*Approved as Corrected
Signed by [Signature]*

DRAINAGE REPORT

MASTER PLAN
RUSTIC HILLS NORTH CENTER
(Rustic Hills North
Filing Number One)
(Rustic Hills North
Filing Number Two)

DRAINAGE PLAN

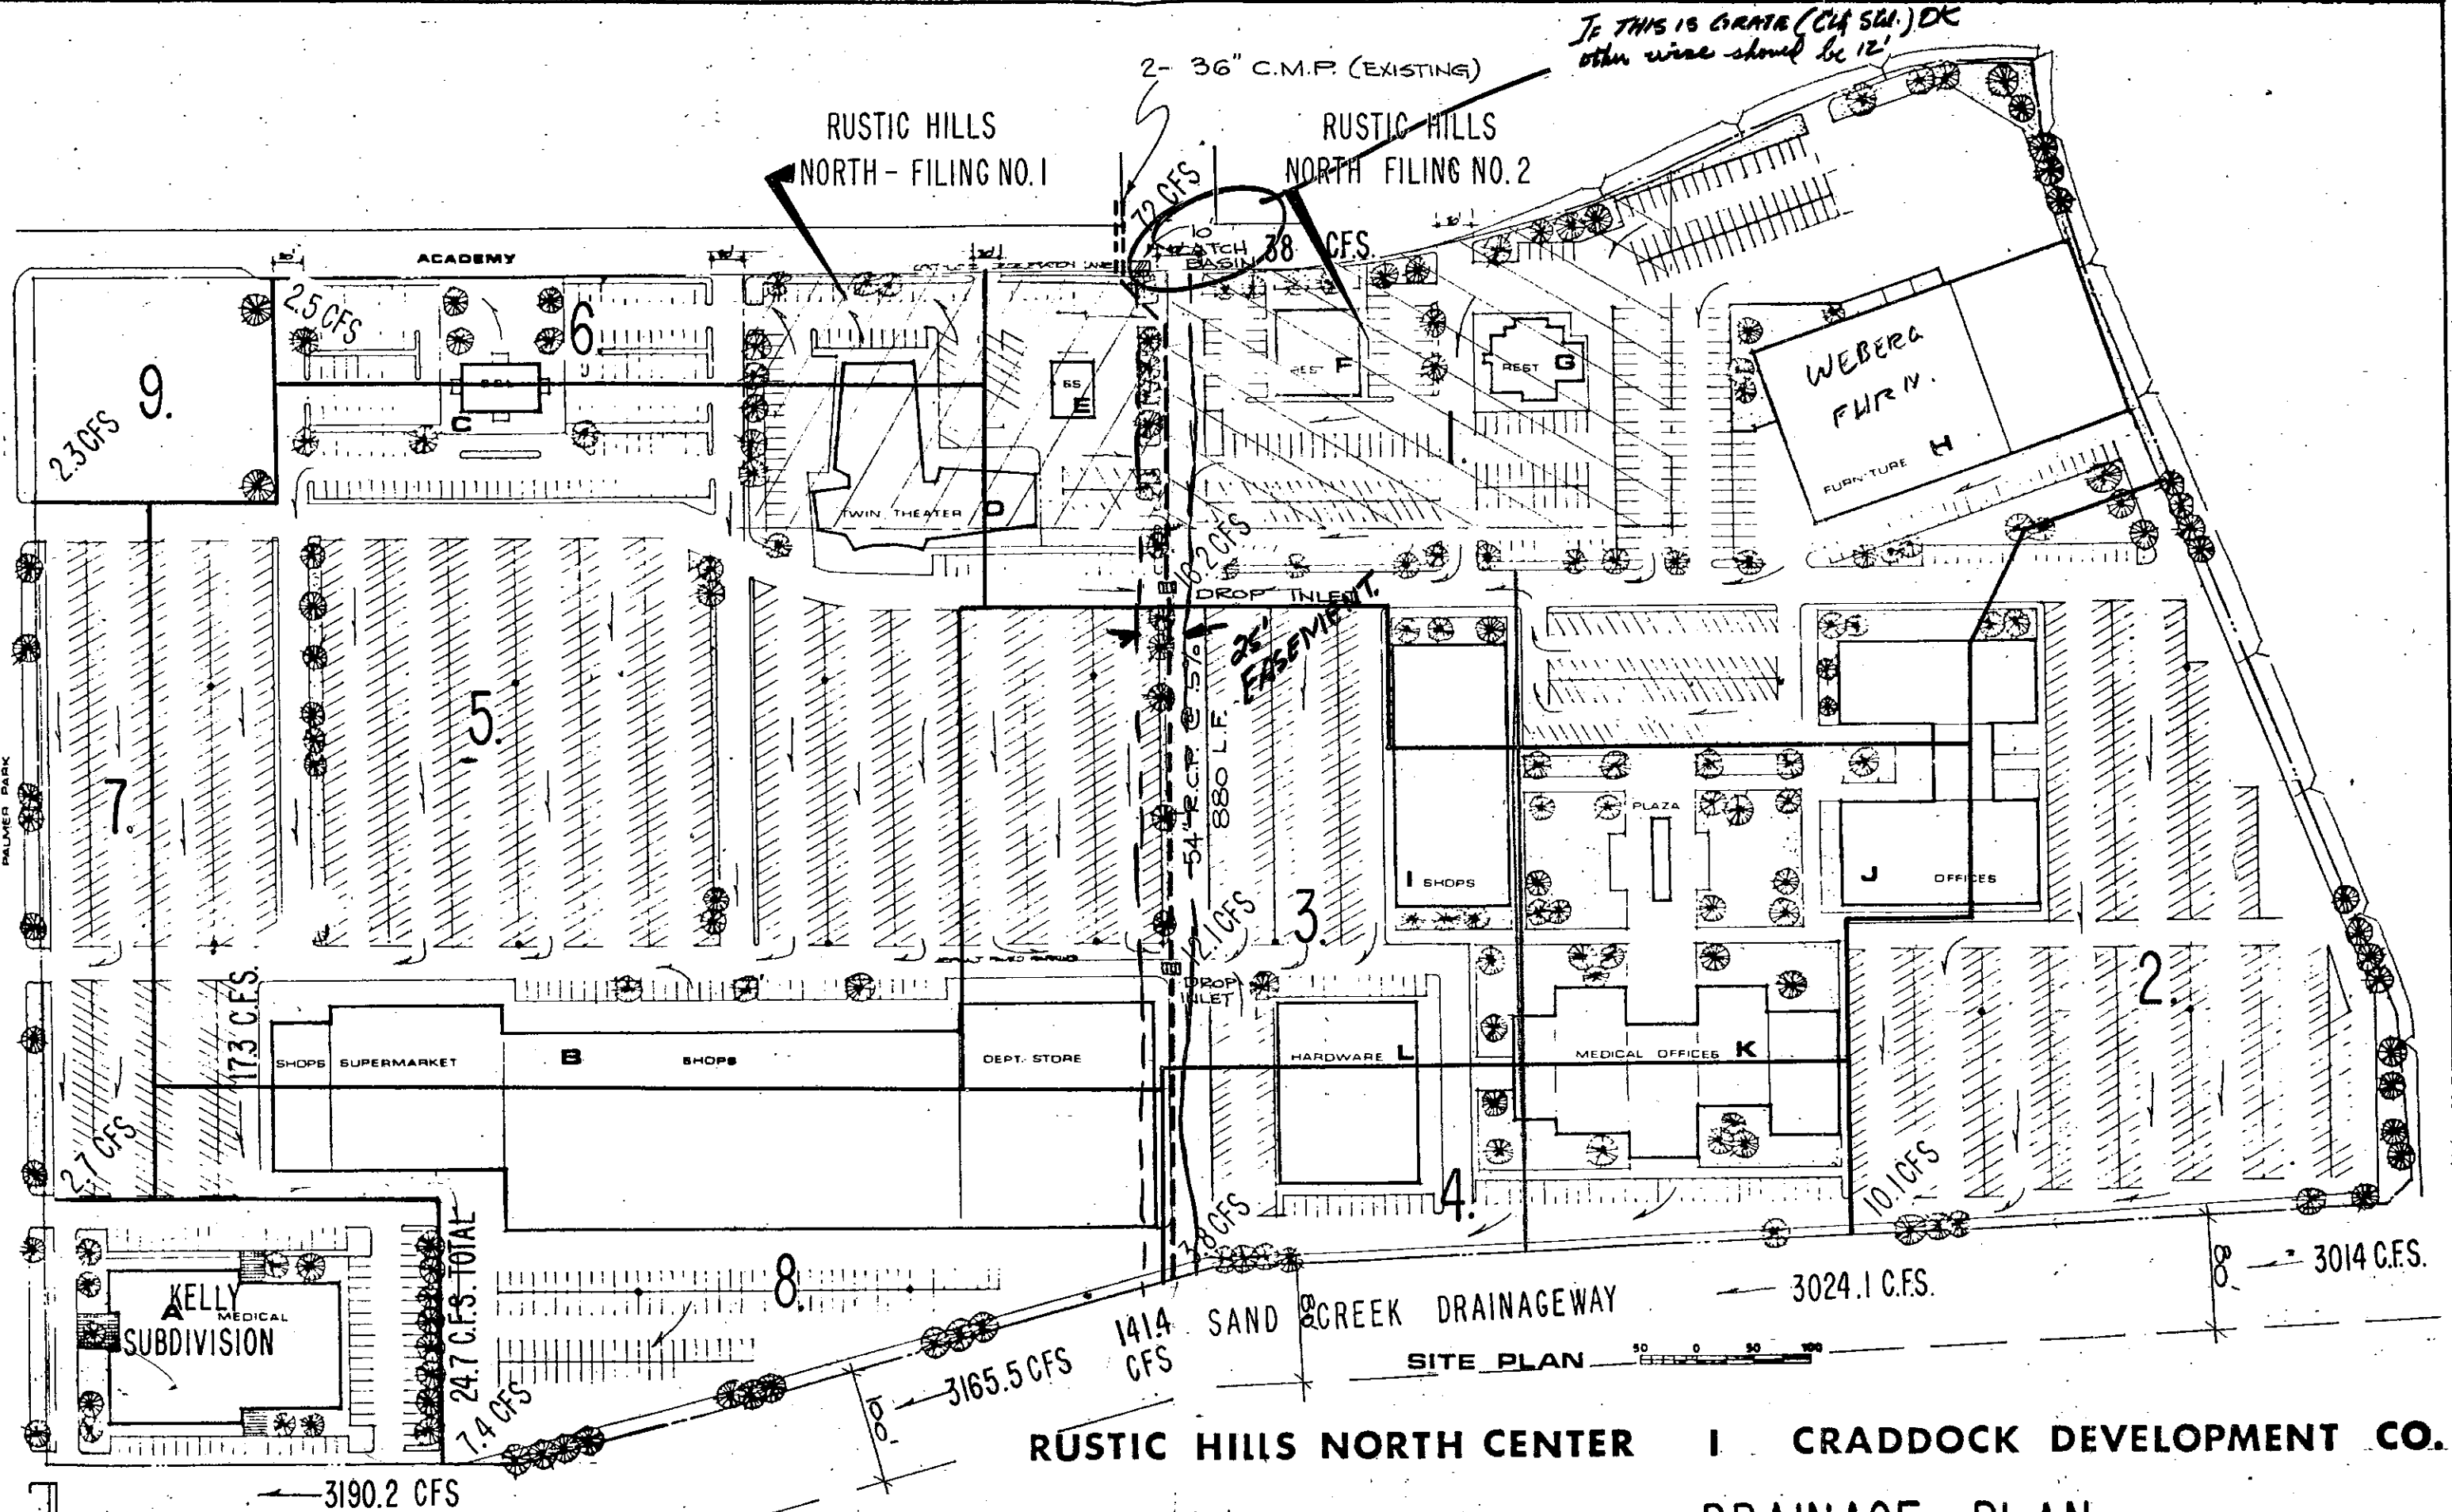
*If this is GRATE (CL 54) DC
other wire should be 12'*

RUSTIC HILLS NORTH CENTER
PROPOSED DRAINAGEWAY DITCH
 SKETCH

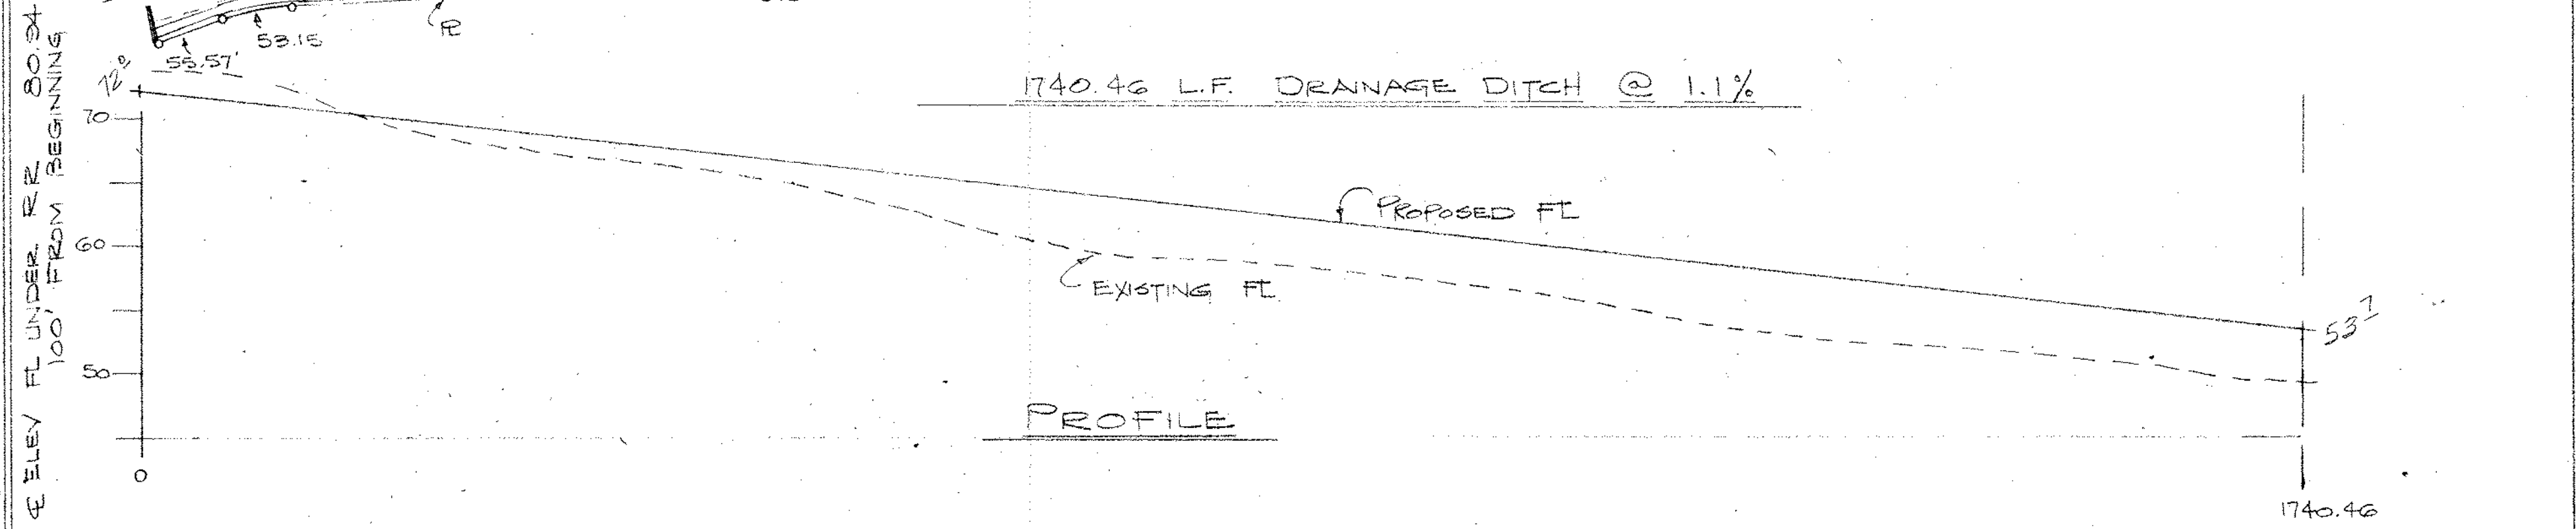
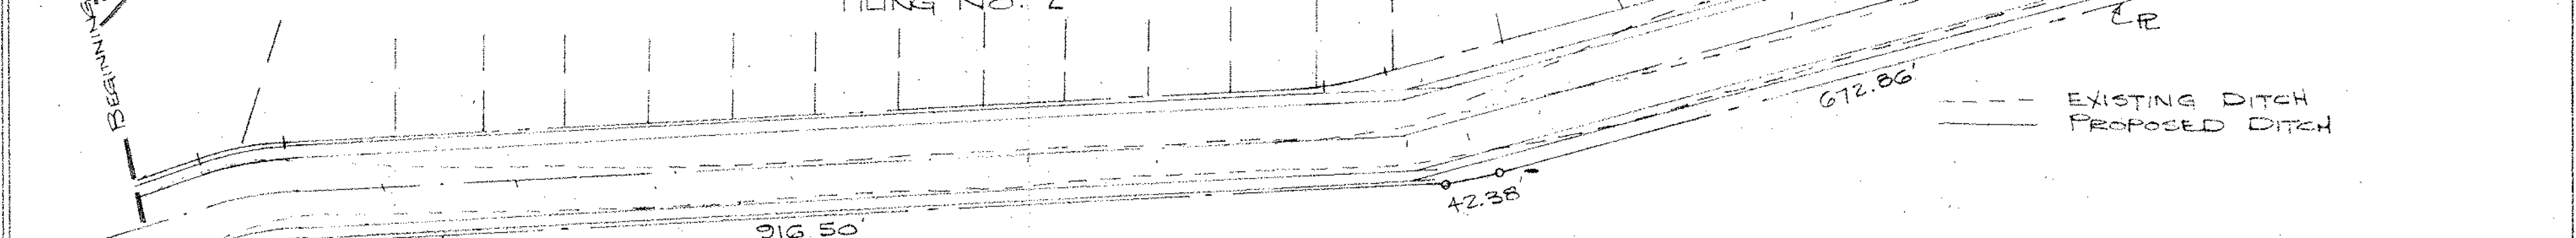
$n = \frac{1.486}{0.3} = 49.5333 \checkmark$
 $a = 277.88$
 $P = 71.22$
 $r = 3.902 \checkmark \quad r^{2/3} = 2.479 \checkmark$
 $S^{1/2} = .1049$
 $S = 1.1\%$
 $Q = 3579 \text{ C.F.S.} \checkmark$
 $\text{VELOC. } 12.9$
